Reply Comments to C802.16m-08/073

Document Number: 80216m-08/115

Reply comments to contribution C802.16m-08/073 and MMIB performance evaluation

Inaccuracies in MMIB - 2

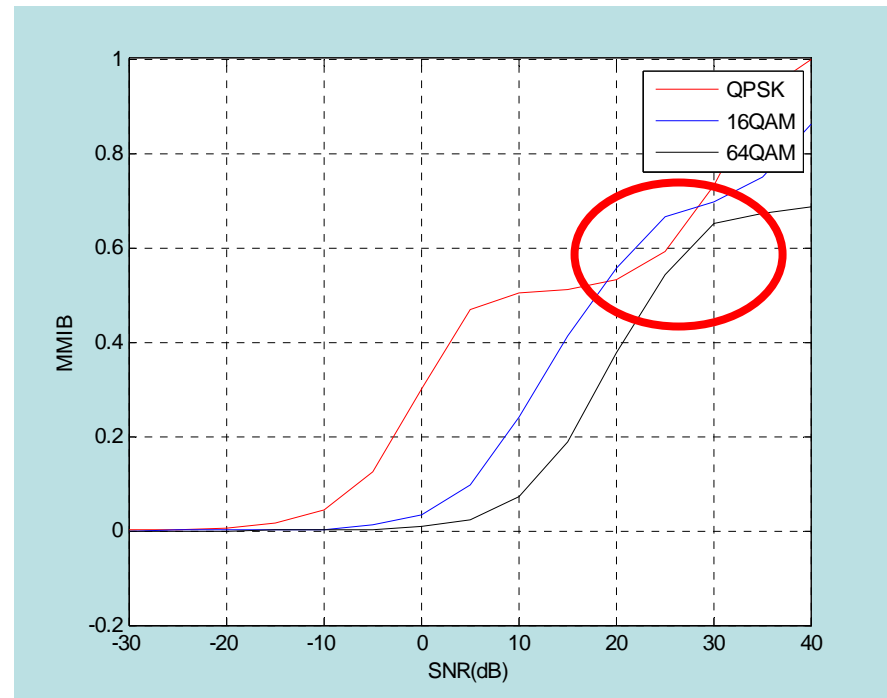
Consider the following example for the channel matrix, H

It can be seen that MMIB does not satisfy the basic property that the bit-level information metric should decrease with increasing modulation level.

16QAM MMIB vs. RBIR SNR=10dB

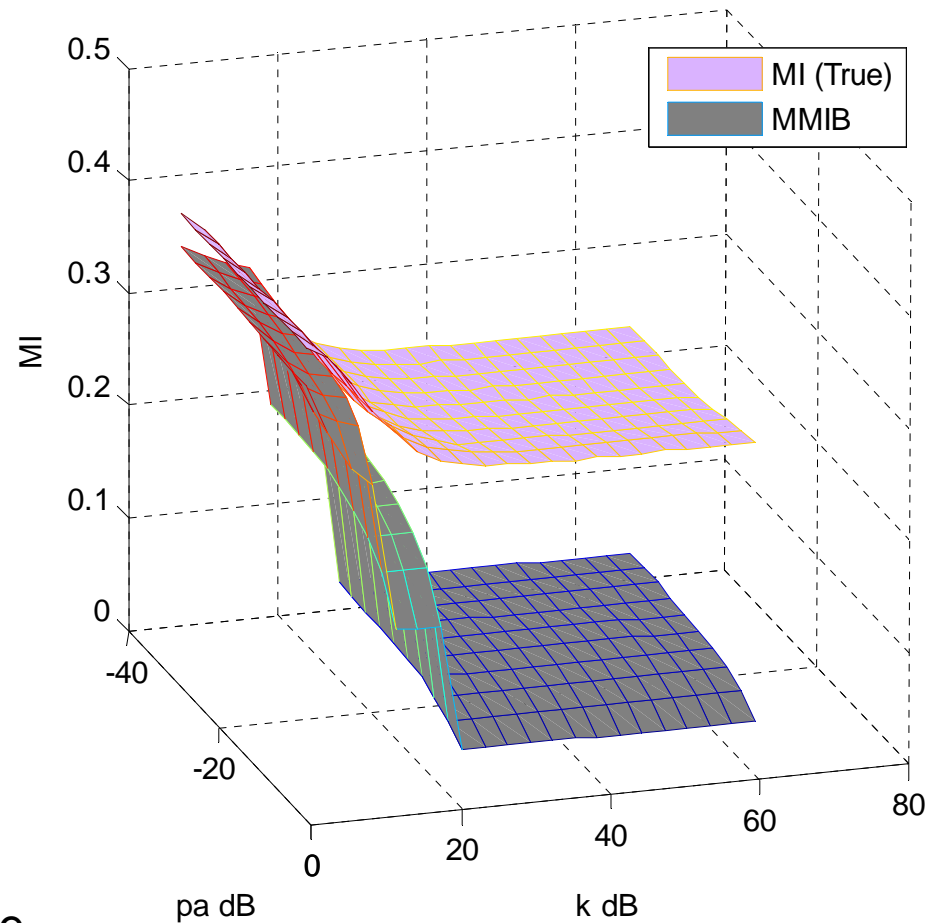
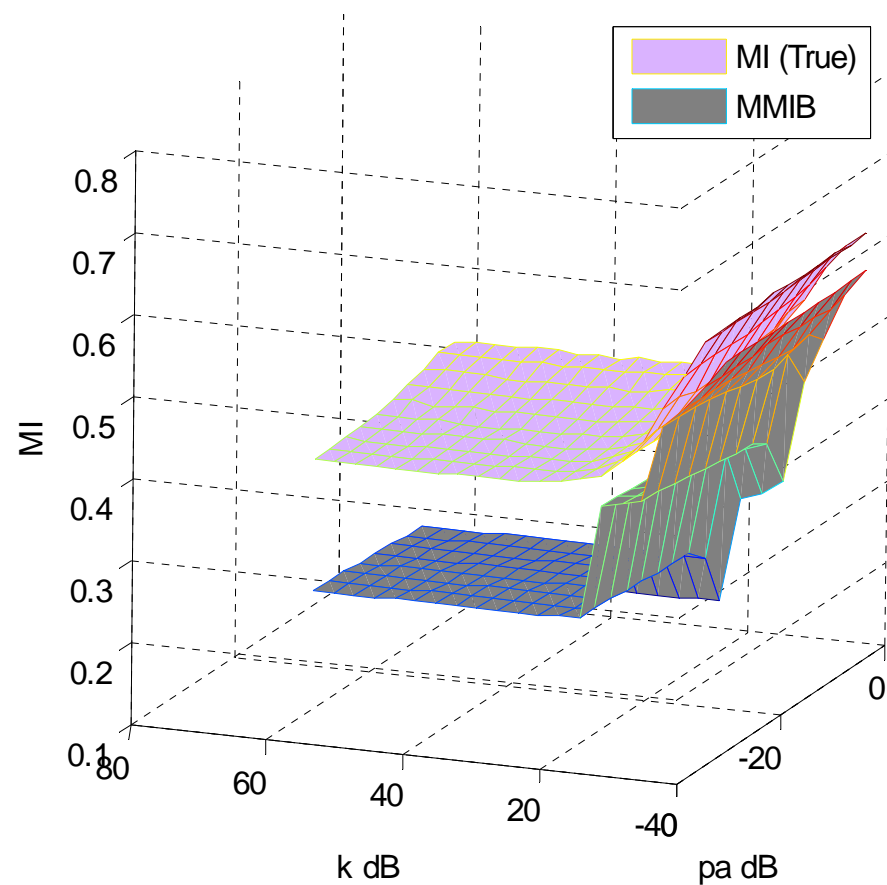
- MMIB PHY abstraction is inaccurate
- Different offsets may be needed for different k/pa and MCS levels

Inaccuracies in MMIB - 4

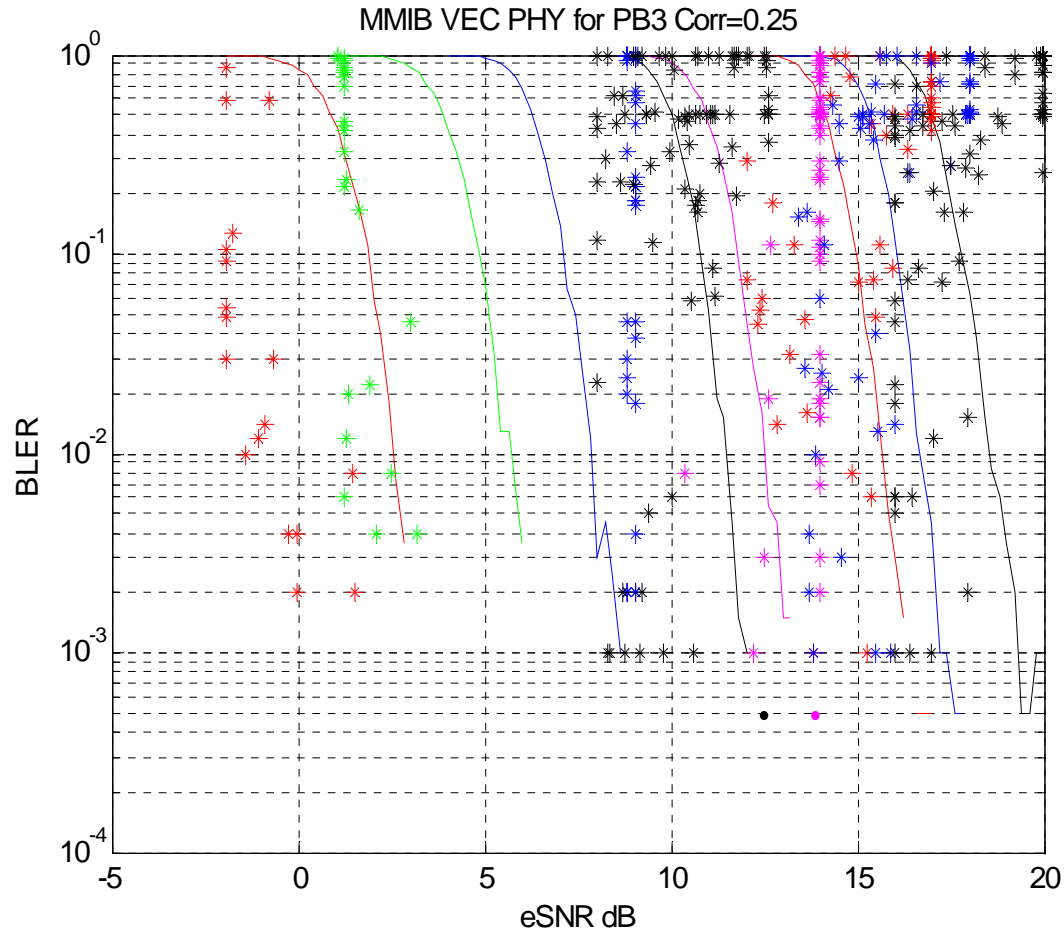
- MMIB PHY abstraction is inaccurate, especially for higher MCS levels
- Each MCS may need different offset
